METROPOLITAN GOVERNMENT OF NASHVILLE AND DAVIDSON COUNTY

STAFF RECOMMENDATION
1709 Fatherland Street
October 17, 2012

Application: New Construction - addition
District: Lockeland Springs-East End Neighborhood Conservation Zoning Overlay
Council District: 06
Map and Parcel Number: 08314013300
Applicant: Bob Borzak, Designer
Project Lead: Sean Alexander, sean.alexander@nashville.gov

1709 Fatherland Street, front.

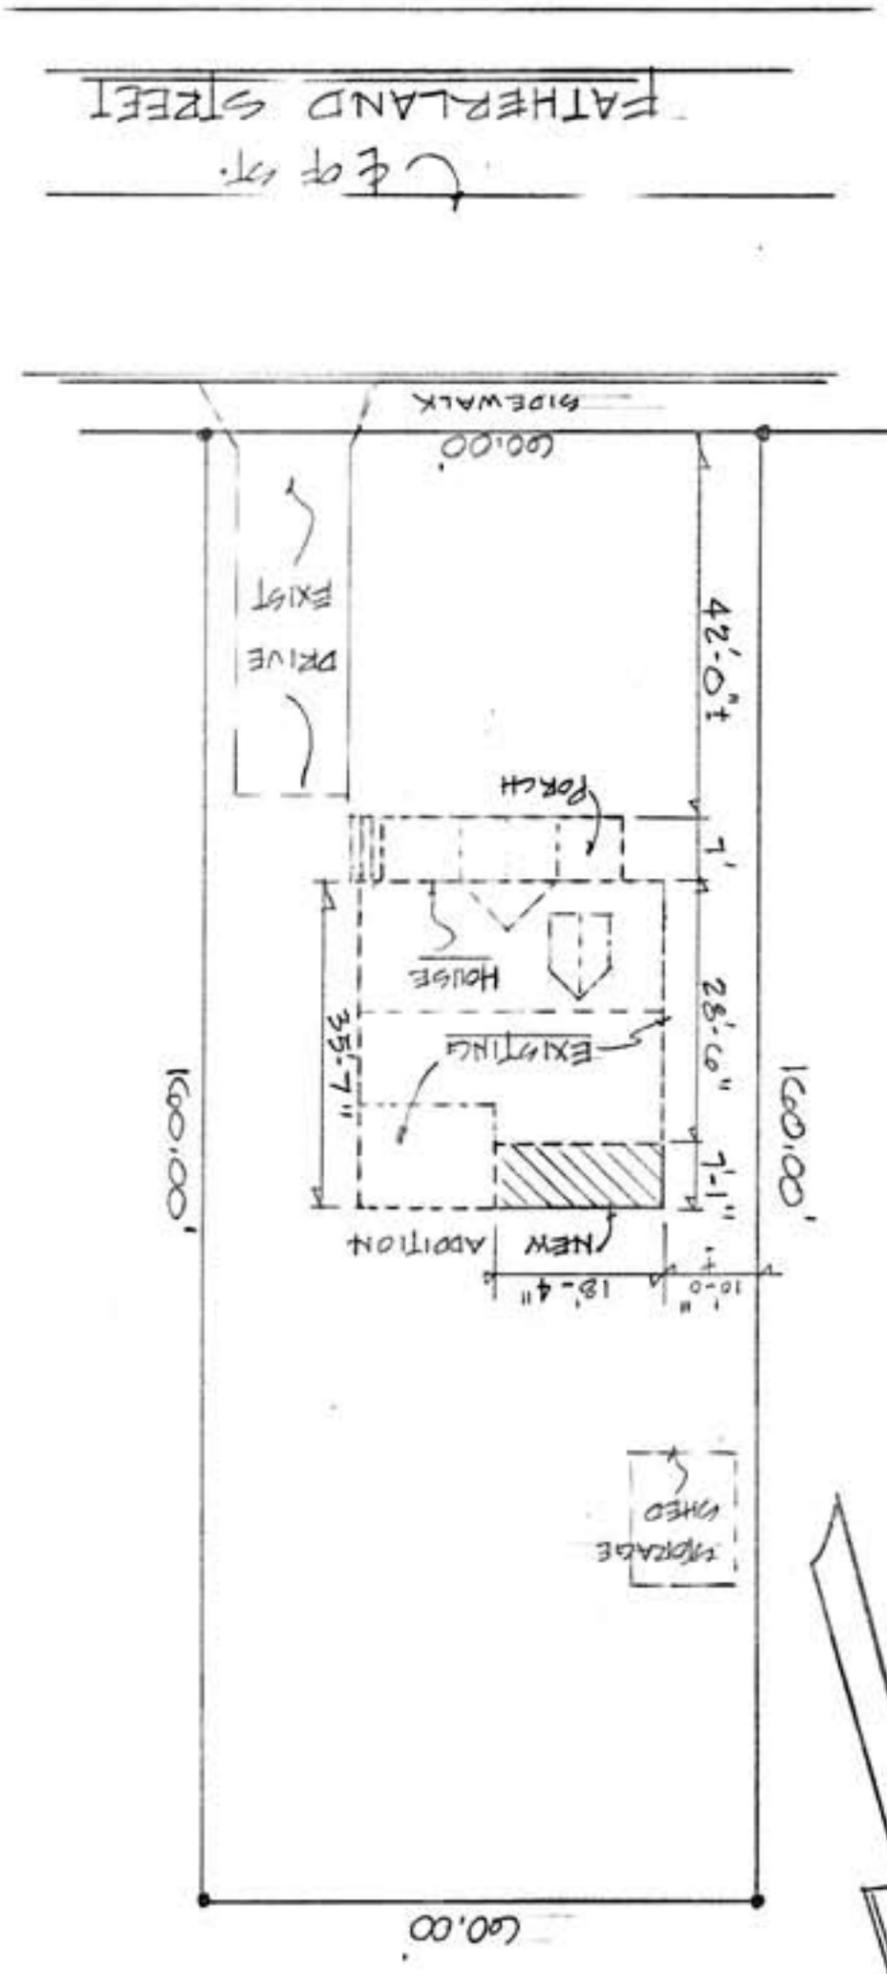
1709 Fatherland Street, side.
Construction of staff-approved addition is underway.

SITE PLAN

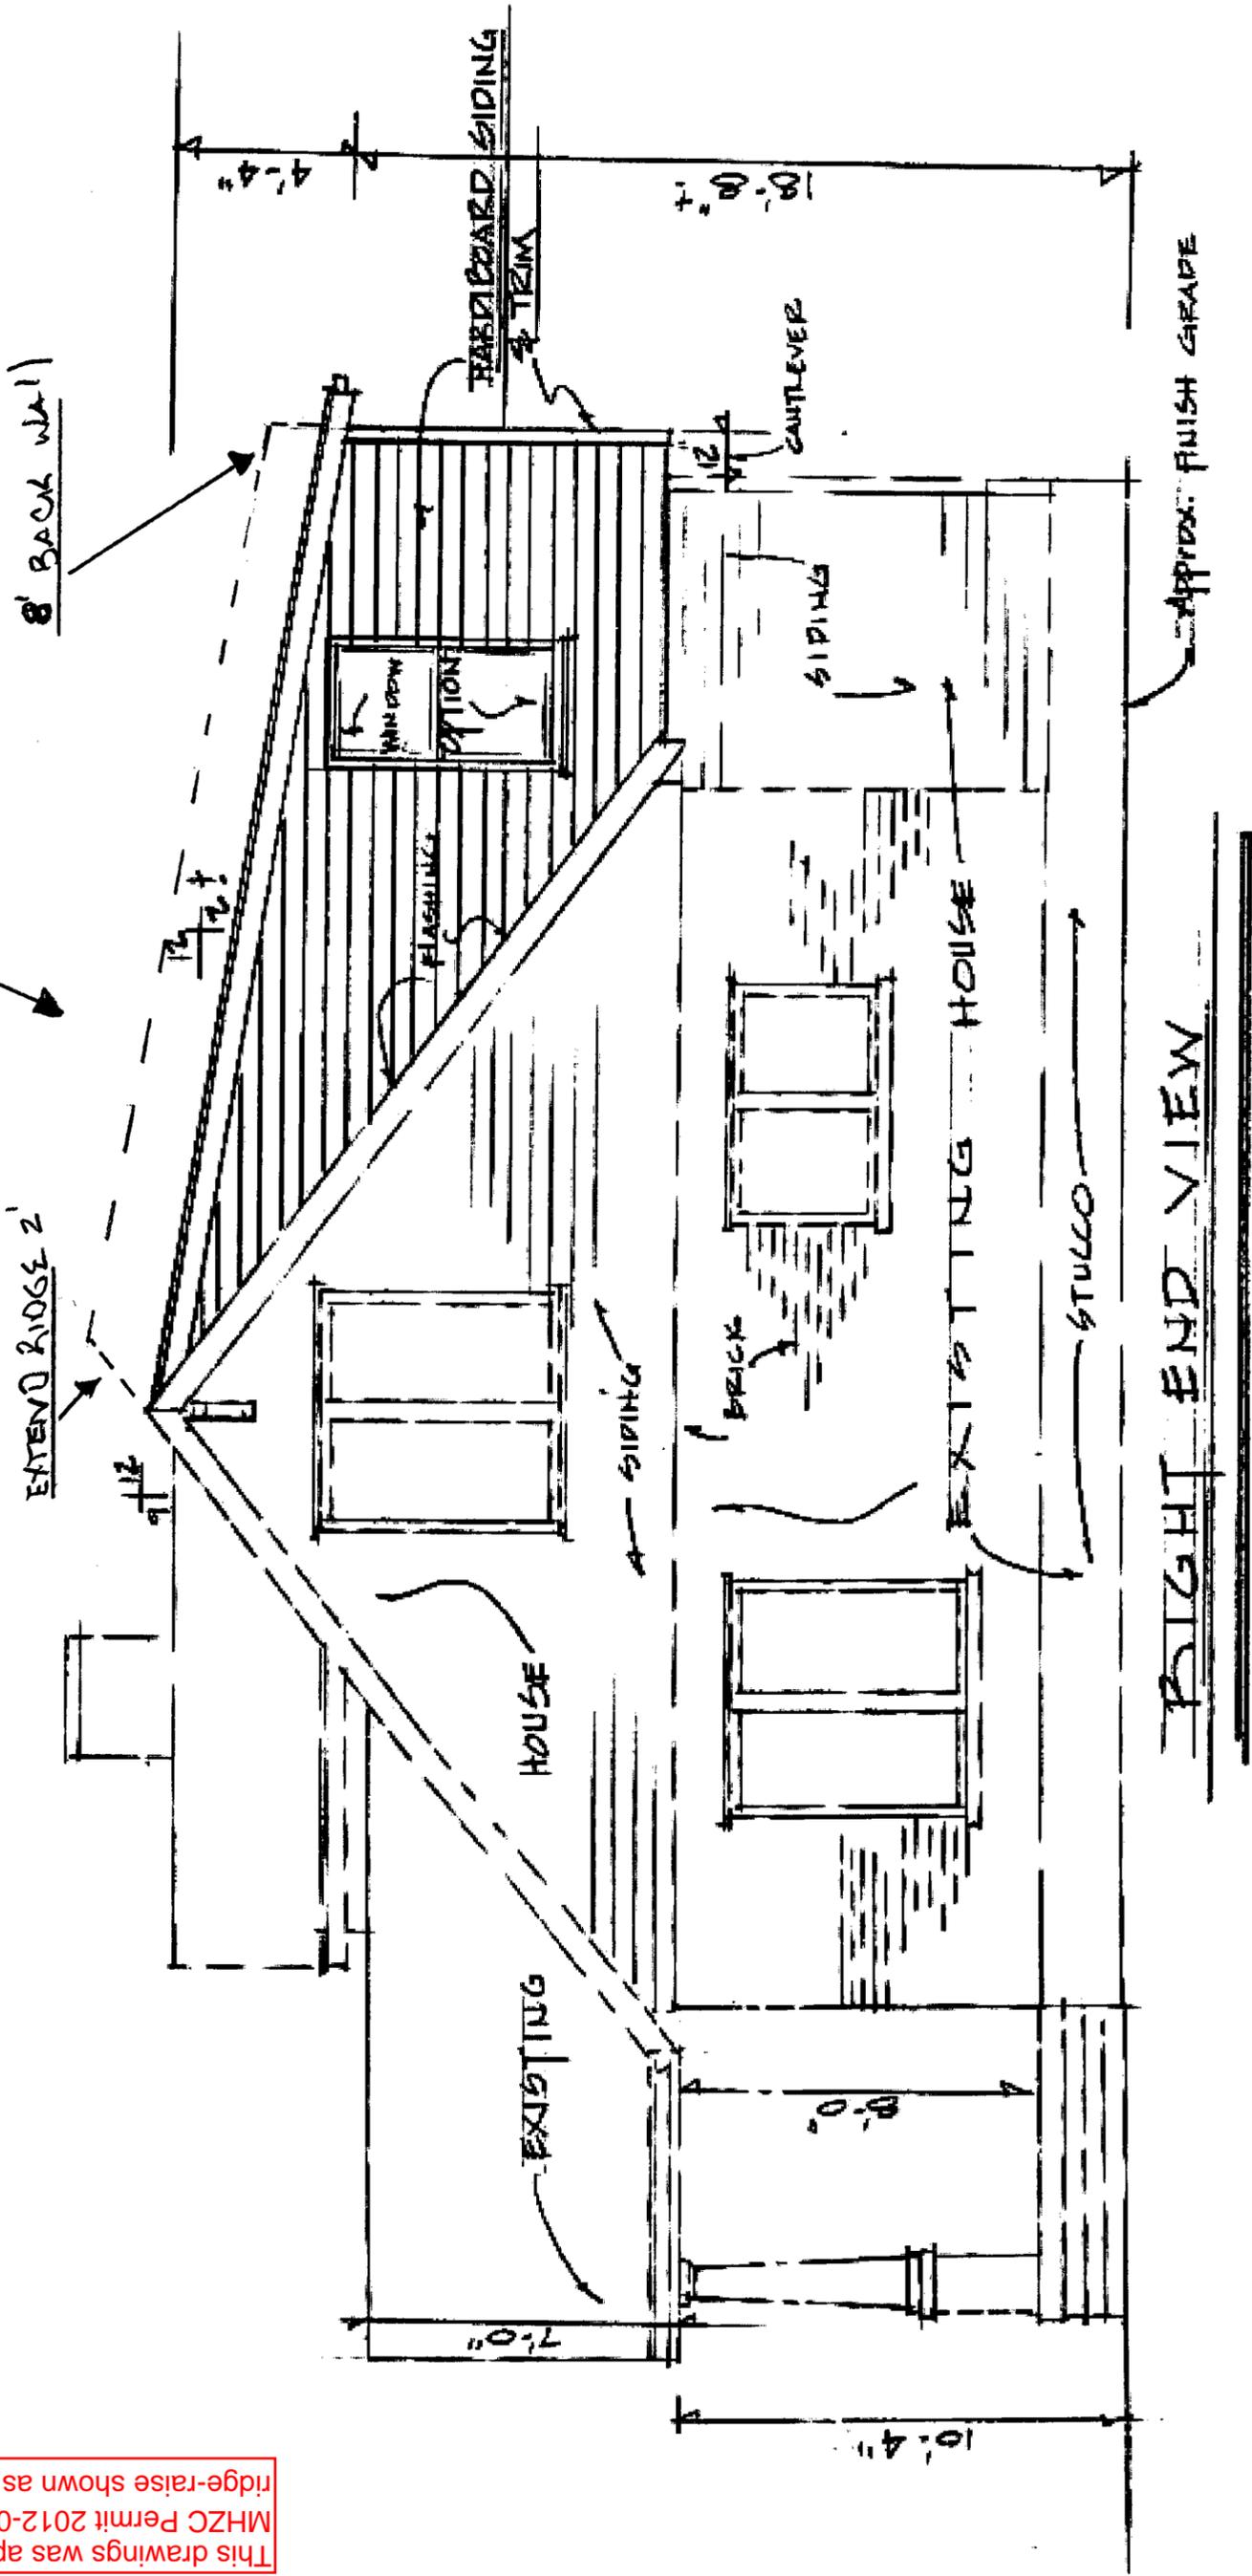
This drawings was approved by
MHZC Permit 2012-00201, with new
ridge-raise shown as dashed line.

CHANGE PITCH TO 3/12
